HPC EXECUTIVE SECRETARY
 EXEMPTION DETERMINATION FOR MINOR ALTERATIONS
 AND TAX CREDIT PRE-APPROVAL

**3801 Old Columbia Pike, Ellicott City
Minor Alteration Determination**

~~AMENDMENT~~
~~GENERAL APPLICATION FOR CERTIFICATE OF APPROVAL AND~~
~~TAX CREDIT PRE-APPROVAL~~

This document amends original approved HPC-20-54 dated August 6, 2020 application AND conforms to the approved MHT 2020 - 161 dated December 10, 2020 application.
SUBMIT 10 COPIES of this application package, including all supporting materials required on pages 2-5 of this application to Howard County Department of Planning and Zoning. Applications must be received no later than 5:00 pm 22 days prior to the meeting. Applications can be submitted via mail, but may result in missing the deadline. Applications are not accepted via email or fax.

1 new rear (south) elevation
scale: 1/4" = 1'-0"

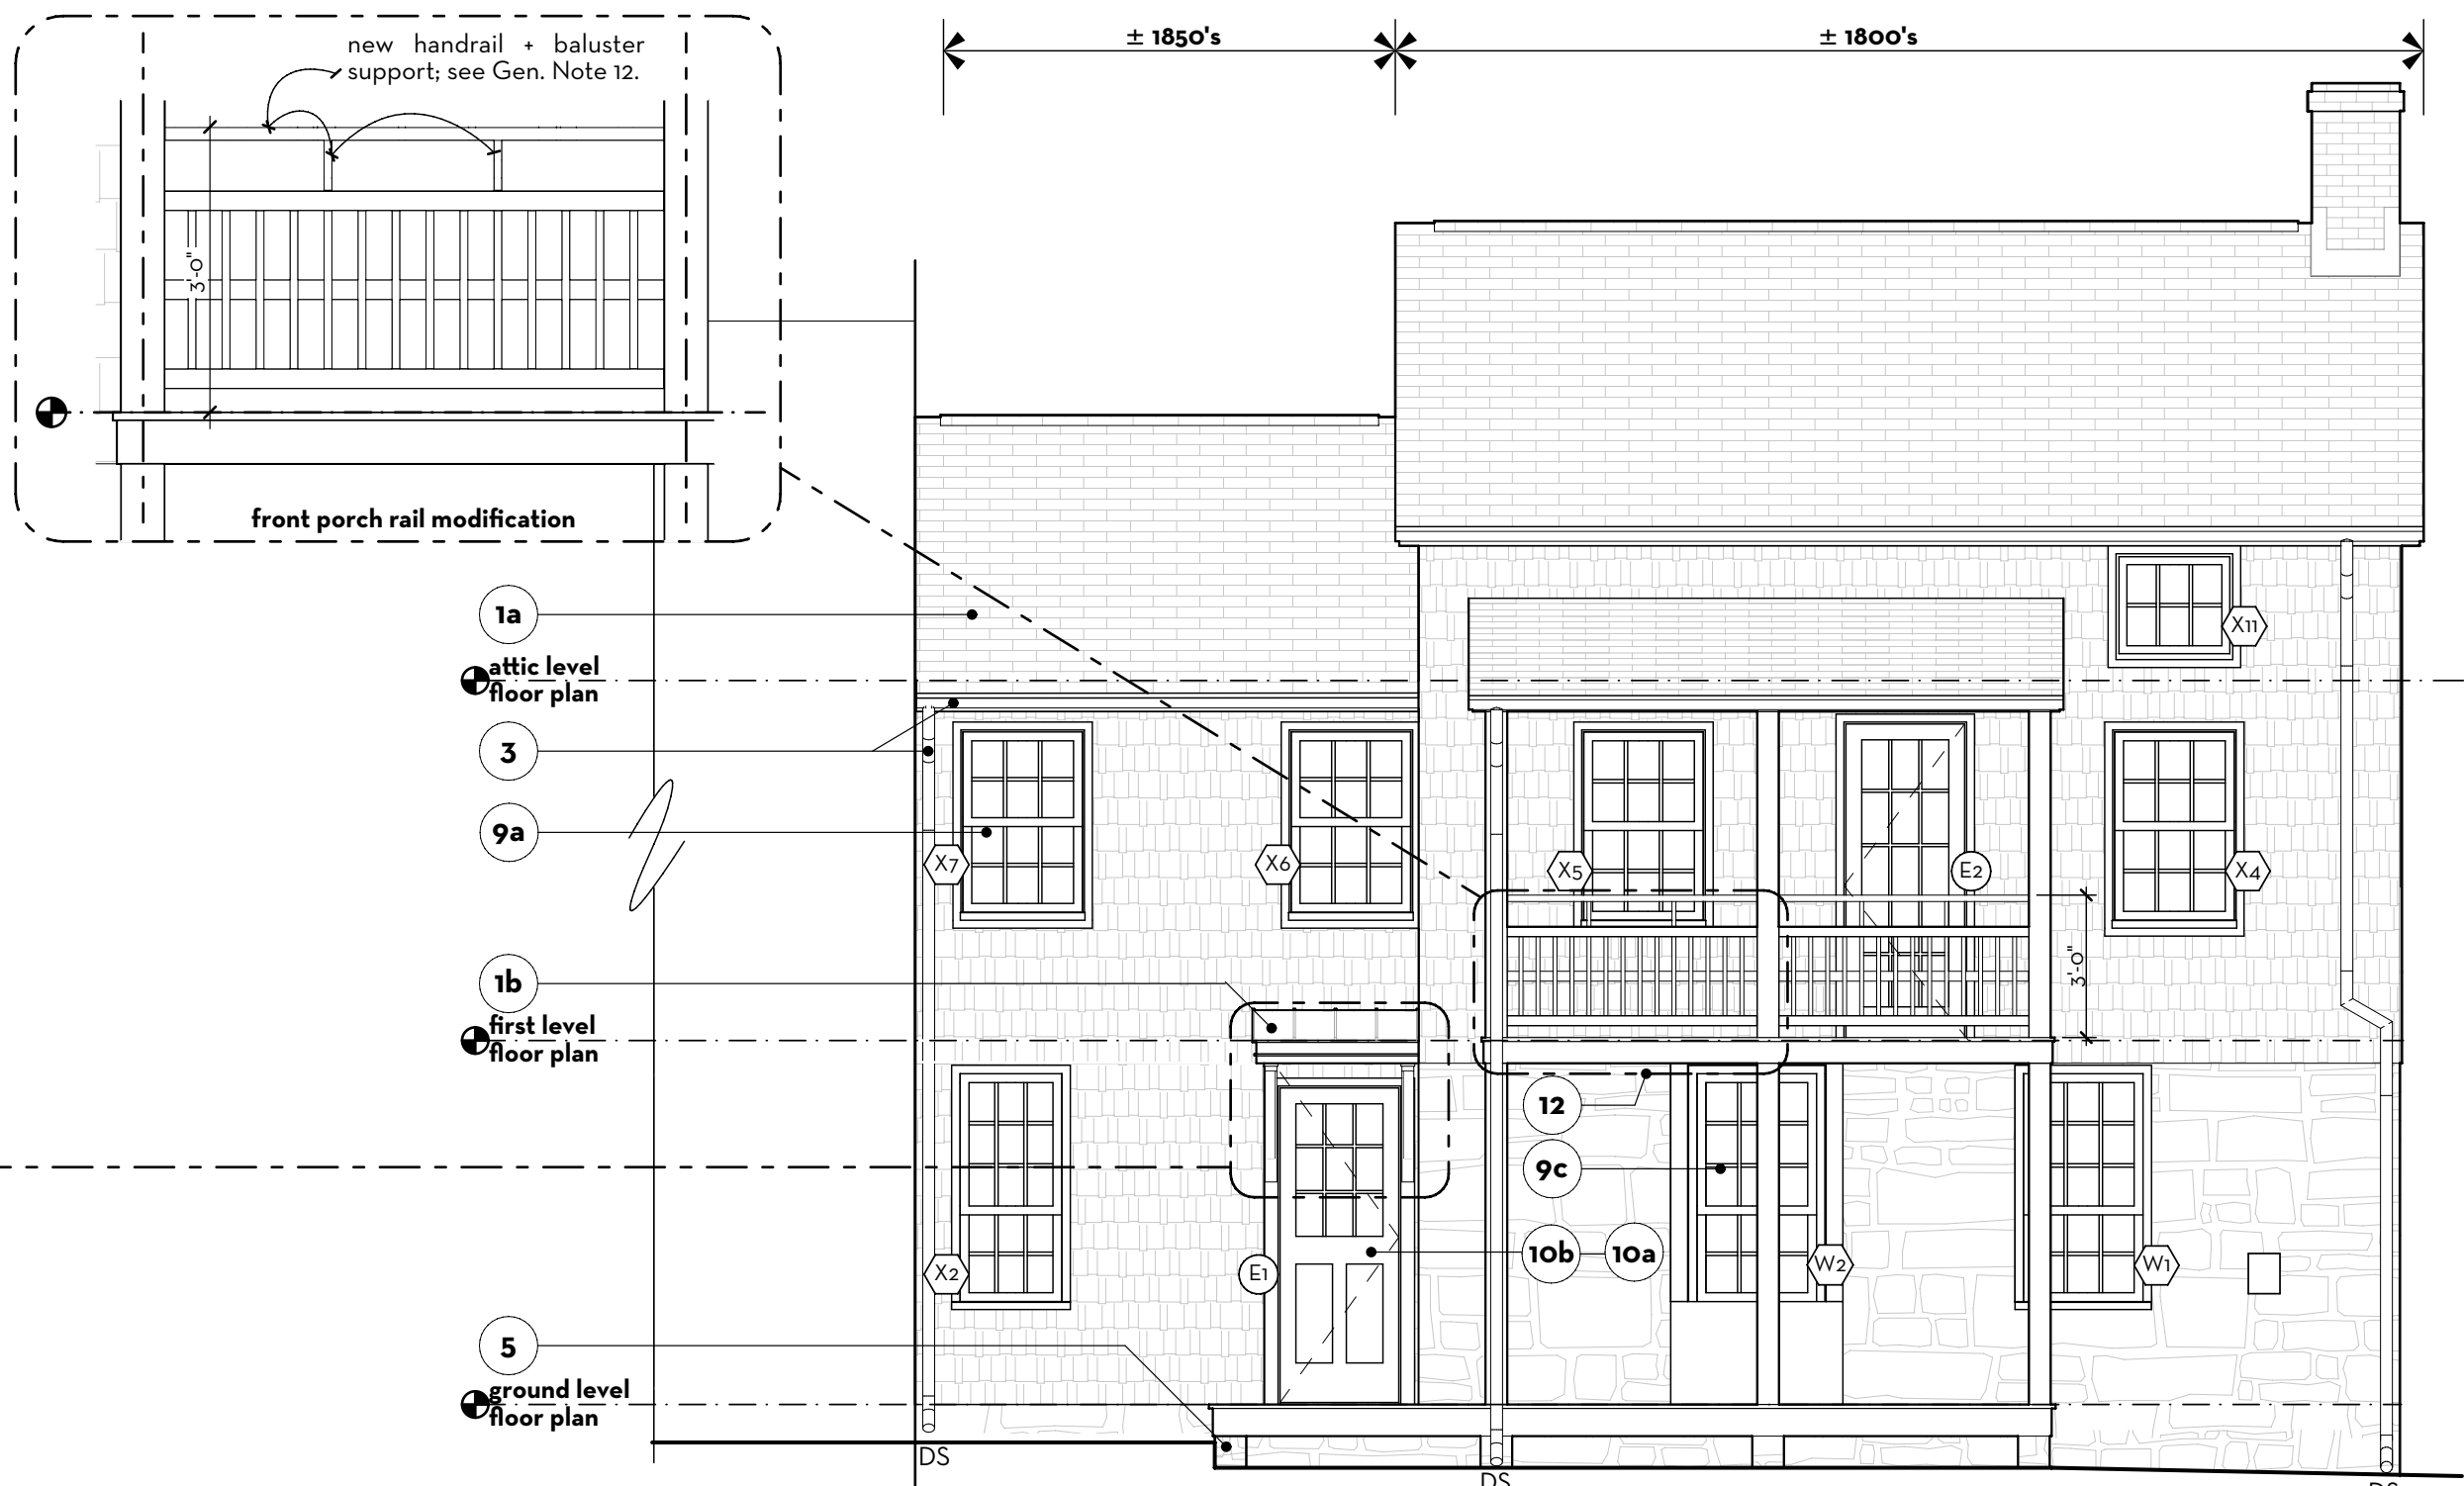
- Work Item #7: We have revised the design of the rear, attic dormer to reflect MHT comments. It is now 1'-6" less in width with the window configuration reduced from 3 to 2. This is the minimum width allowing for an egress casement. The new dormer continues to align with the first floor wall as the current dormer does. Its structure rests on the outside wall, and any alteration to face of dormer moving inward toward the roof would require modification to existing wall and roof structure.
(Summarized Item Response continues on next sheet)

Work Item #11: The rear addition (bay) design has been modified to retain the existing door and window openings. The width of the bay is unchanged as it must encompass the (2) existing openings plus 6" each side for opening casing/trim. Historic and architectural considerations were evaluated during the design process. The bay does not interfere with the smaller volume of the hyphen, nor does it extend beyond the transition between the main house volume and that of the hyphen. By setting it inward from the original east dividing wall it presents itself as a small outdoor garden volume element while still allowing the main volume of the house as well as that of the hyphen to read through. Design and historic appropriateness considerations were also given to the window lite arrangements, where the lites of the casement windows and the awnings above mimic the ratio and scale of lites in the historic house.
